Access Compliance Report

Public Rights-of-Way

(Curb Ramps)

Intersection ID: 14154	Main Street: DILWORTH_RD	Cross Street: MT_VERNON_AV	Location: SW
ADA ID: 19D17499F420	Ramp Type: PerpDiag	Initial Pass/Fail: Fail	Overall Compliance: No
Severity Score: 13.75			
Codes/Mitigation Info/Possible Solution		Field Measurements/Component Compliance

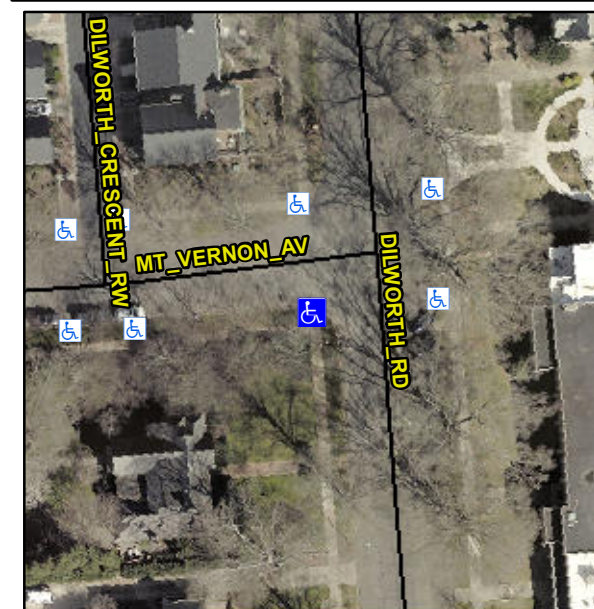
R304.2.2, R304.5.3

Compliance	Description	Data	Compliance	Description	Data
N/A	Ramp Length (in)	89.0	No	Ramp Slope (%)	8.4
Yes	Ramp Width (in)	48.0	No	Ramp XSlope (%)	2.9
N/A	Flare Type LT	N/A	N/A	Flare Type RT	N/A
N/A	Flare Slope LT (%)	N/A	N/A	Flare Slope RT (%)	N/A
N/A	Flare Traversable LT?	N/A	N/A	Flare Traversable RT?	N/A
N/A	Landing Length (in)	N/A	N/A	DWS Provided?	N/A
N/A	Landing Width (in)	N/A	N/A	DWS Contrast?	N/A
N/A	Landing Slope (%)	N/A	N/A	DWS Length (in)	N/A
N/A	Landing X Slope (%)	N/A	N/A	DWS Full Width?	N/A
N/A	Landing Curb? (Y/N)	N/A	N/A	DWS Offset (in)	N/A
N/A	Shared Landing?	N/A			
N/A	Gutter Ponding?	N/A	N/A	Gutter Slope (%)	N/A
N/A	Gutter Lip Ht (in)	1.0	N/A	Gutter X Slope (%)	N/A
N/A	Painted X Walk1?	No	N/A	Painted X Walk2?	No
	X Walk 1 Direction	To E		X Walk 2 Direction	To N
N/A	X Walk 1 Width (in)	N/A	N/A	X Walk 2 Width (in)	N/A
	X Walk 1 Slope (%)	1.0		X Walk 2 Slope (%)	0.0
	X Walk 1 X Slope (%)	0.5		X Walk 2 X Slope (%)	0.9

Remove & Replace Curb Ramp With Two New Directional Ramps or Equivalent.
